**GENOA CHARTER TOWNSHIP
PLANNING COMMISSION
PUBLIC HEARING
OCTOBER 27, 2014
6:30 P.M.
AGENDA**

Attention:	Kelly VanMarter, AICP Assistant Township Manager/Community Development Director
Subject:	Cleary University student housing – Special Land Use and Site Plan Review #2
Location:	3750 Cleary Drive – south side of Grand River, between Grand Oaks and Latson Road
Zoning:	OSD Office Service District

Re: Cleary University Residence Hall Plan Review #2

RE: Cleary University – Residence Hall
3750 Cleary Drive
Revised Site Plan Review – Student Housing Apartment Phase 1

OVERALL SITE PLAN

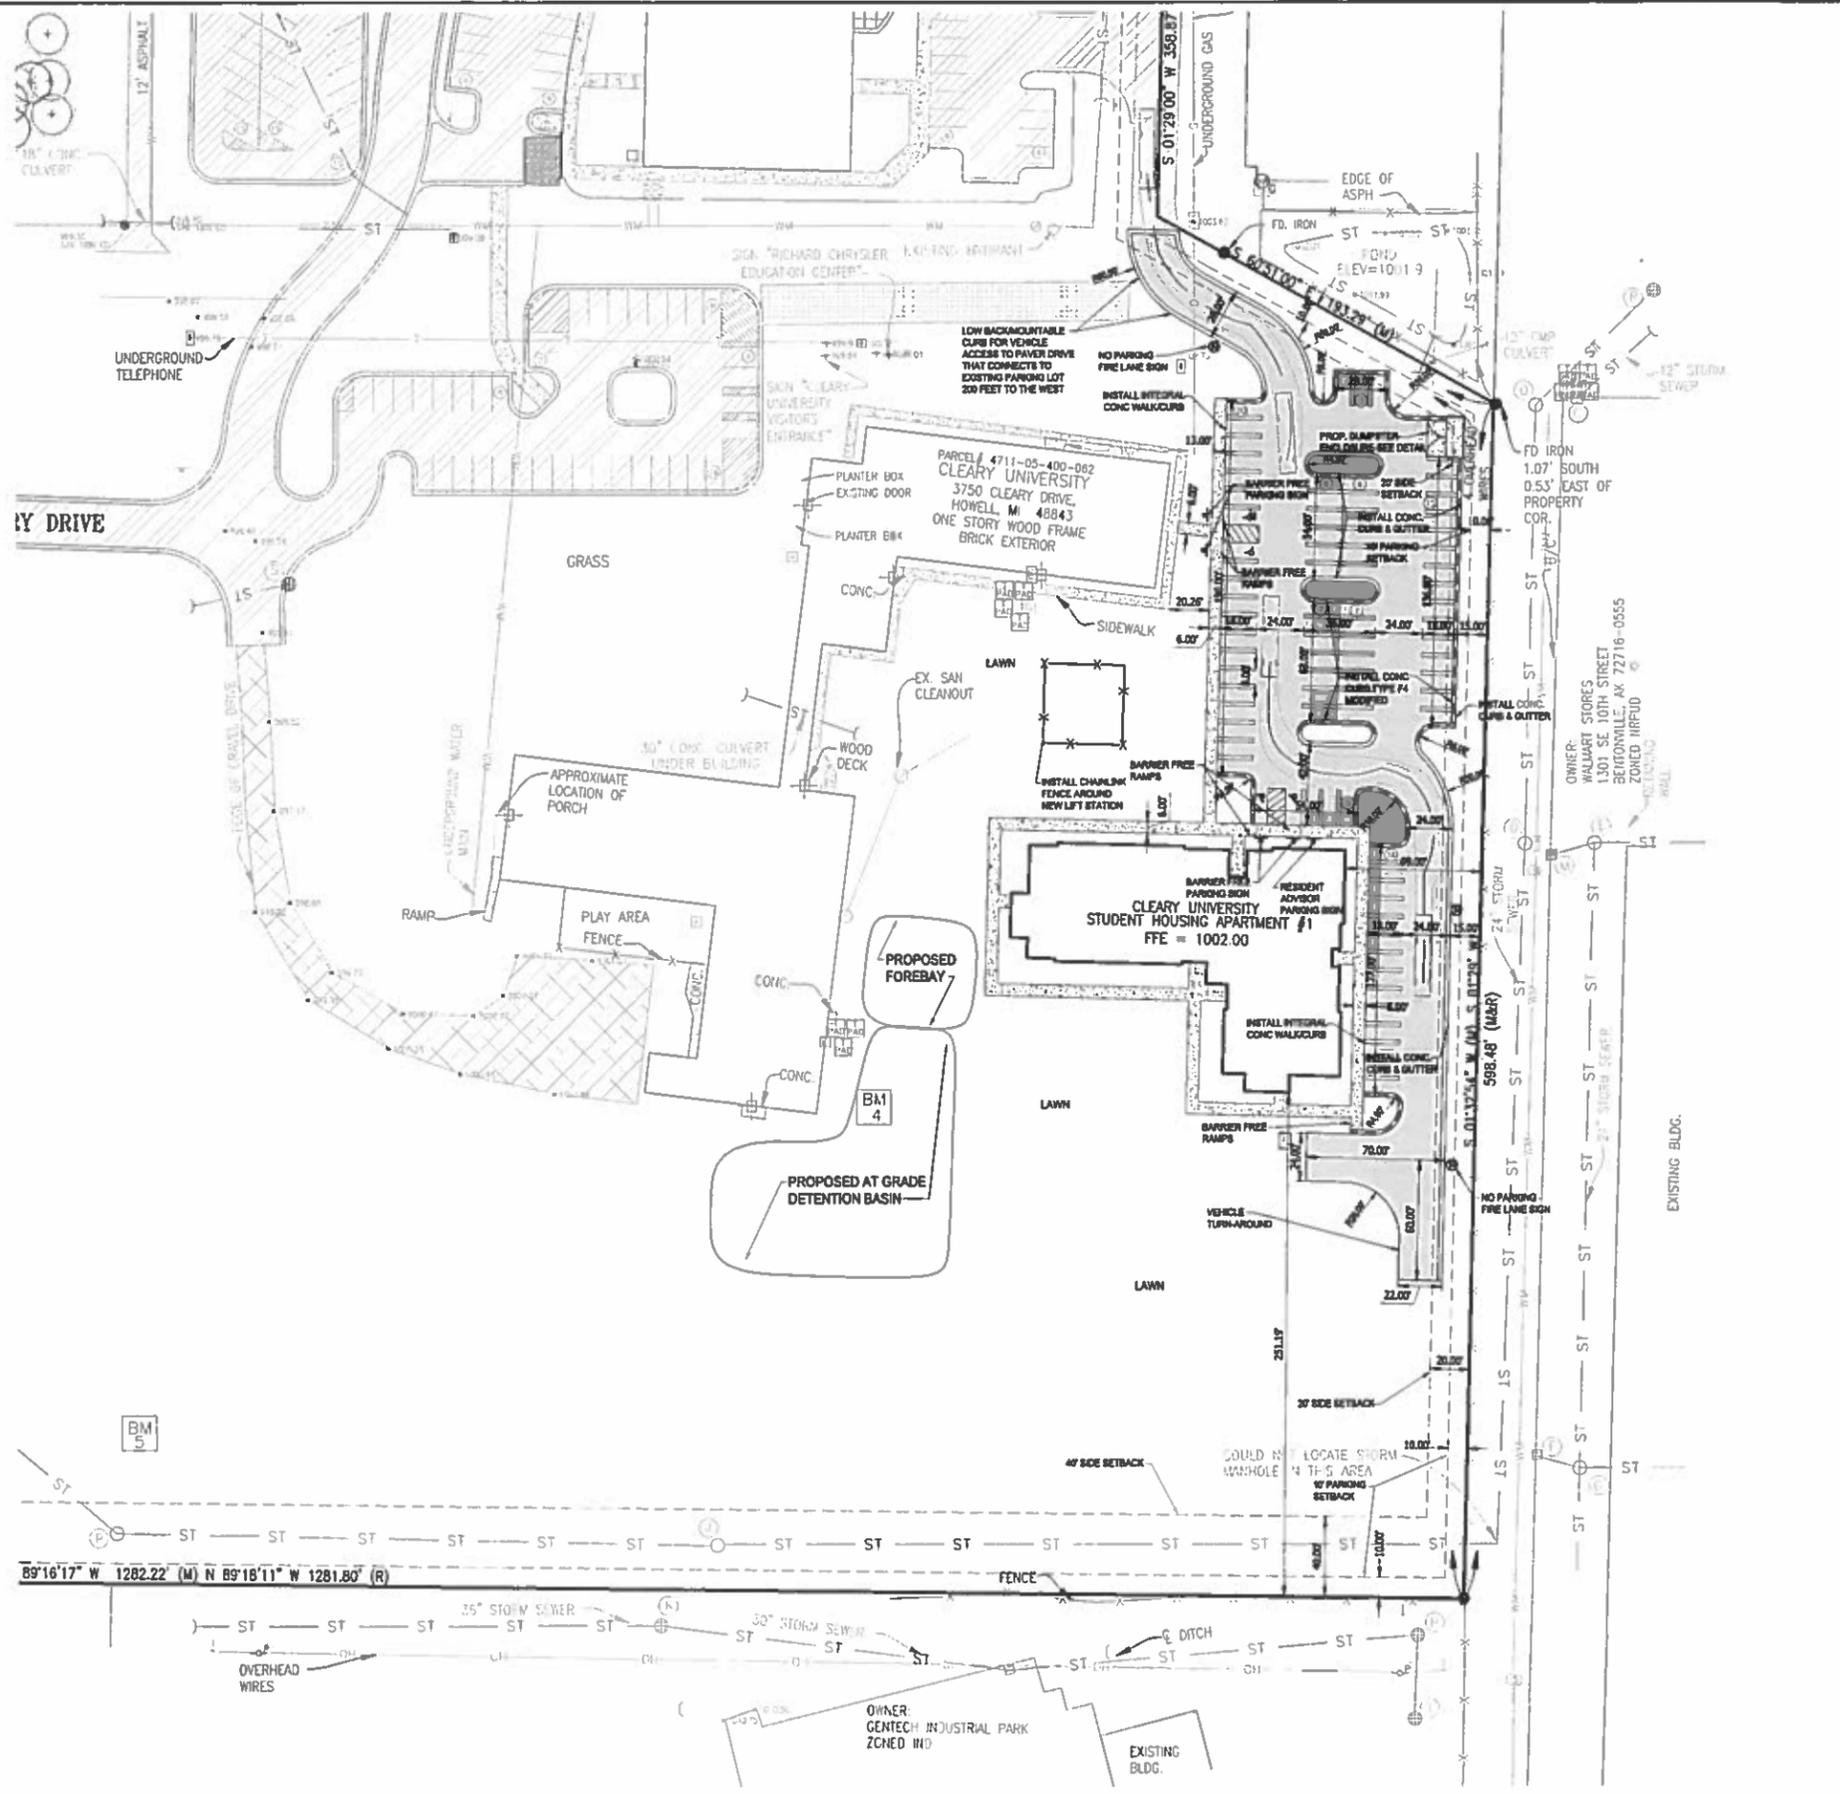
Sheet 3 includes a breakdown of parking on-site, which is based on need/demand as opposed to the requirements of the Zoning Ordinance. As such, the proposed parking for the student housing exceeds the 120% limitation imposed by Section 14.02.06. Therefore, Planning Commission approval is needed, although the additional parking will likely be absorbed by others on campus.

A1 ELEVATION
A-201 SCALE 1/8" = 1'-0"

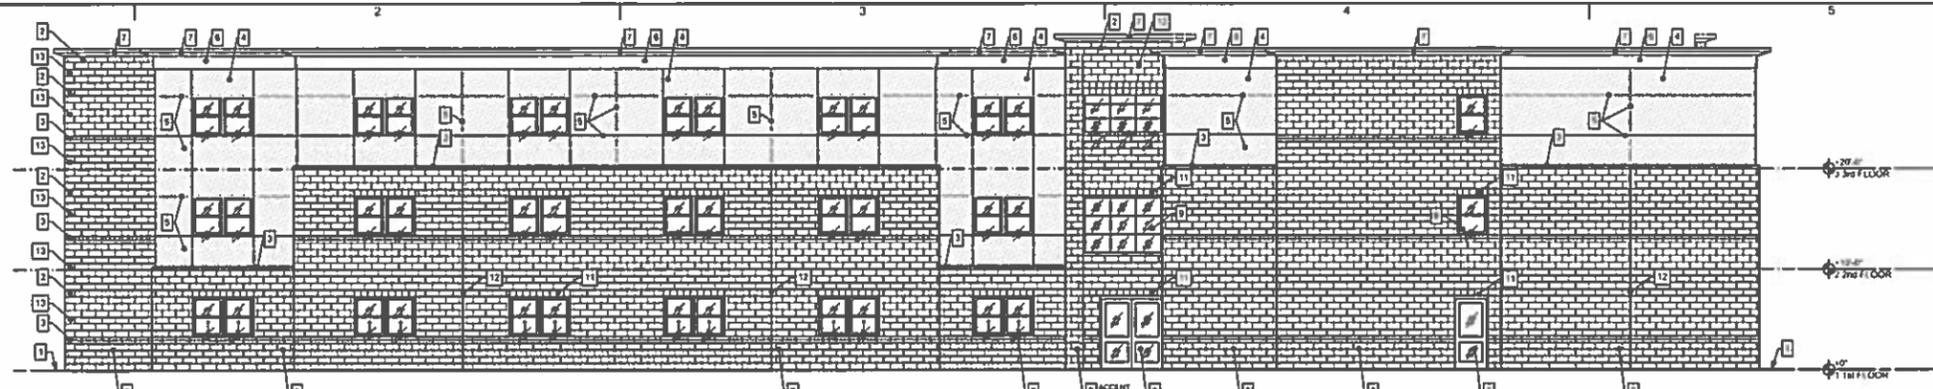
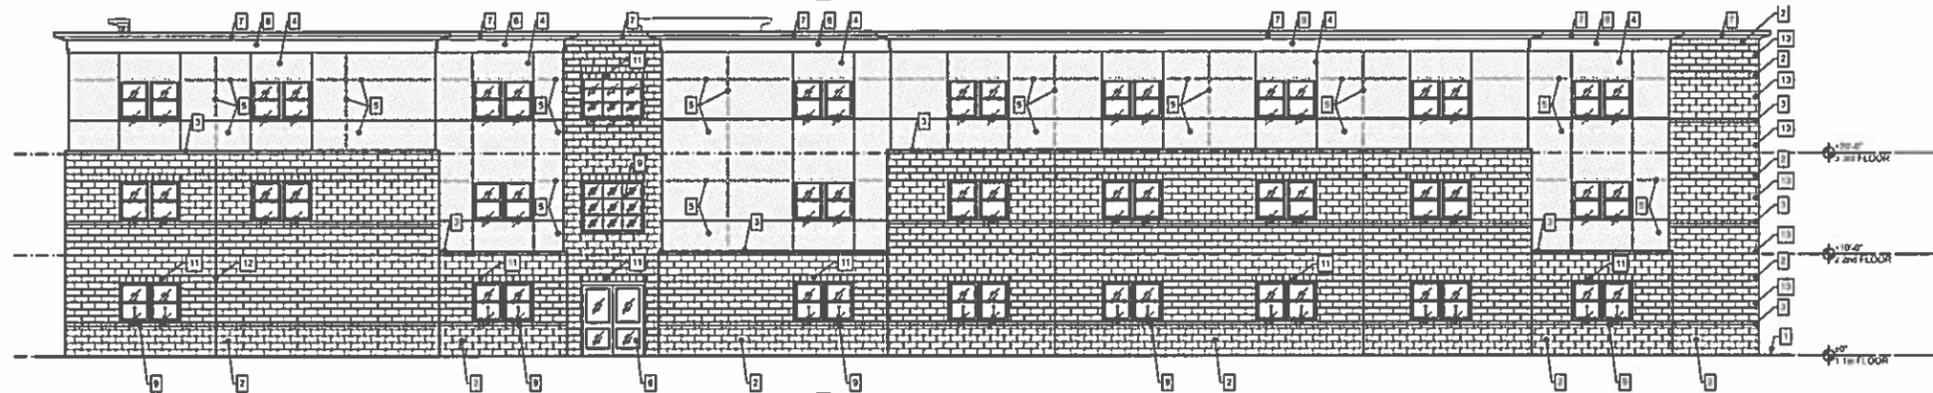
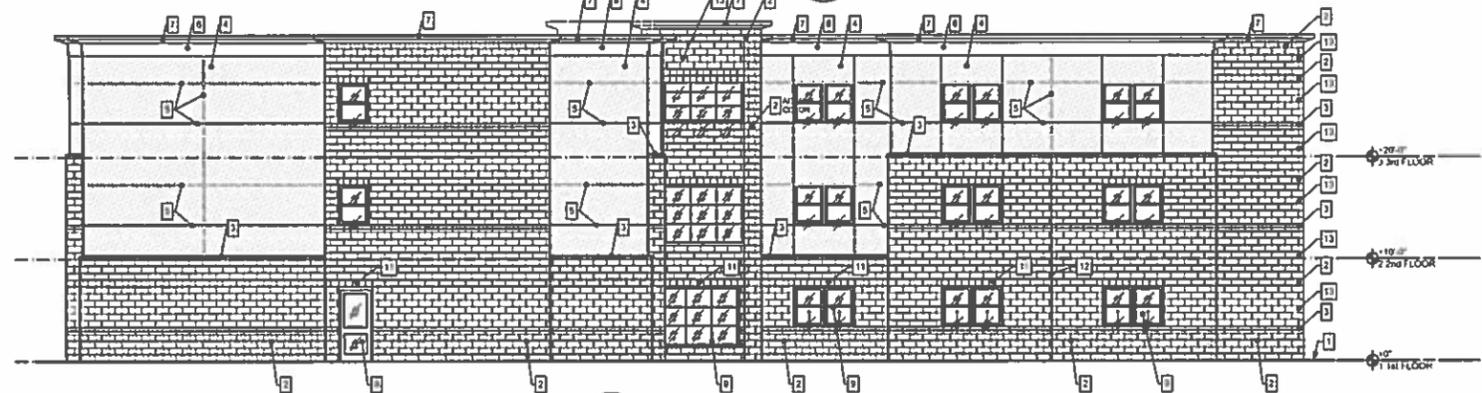
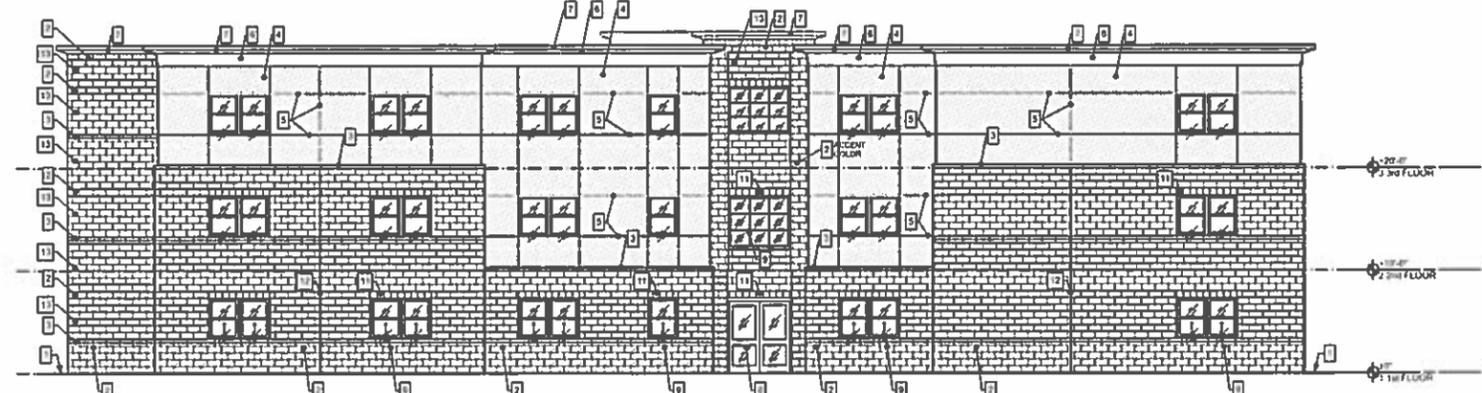
4. The proposed elevations, including colors and materials, are subject to review and approval by the Planning Commission.
5. The proposed building materials exceed the maximum allowable percentages for split-face CMU and EIFS.

6. The Master Plan calls for “high quality” buildings in this area. In order to achieve this, we believe the building materials and design need enhancement.

2. **Building Materials and Design.** The proposed elevations, including colors and materials, are subject to review and approval by the Planning Commission.

As referenced in our special land use review above, the Master Plan specifically calls for “high quality building architecture” in this area. While the proposed building does possess some decorative elements, we do not believe the design and materials fully reflect the type of building envisioned by the Plan.
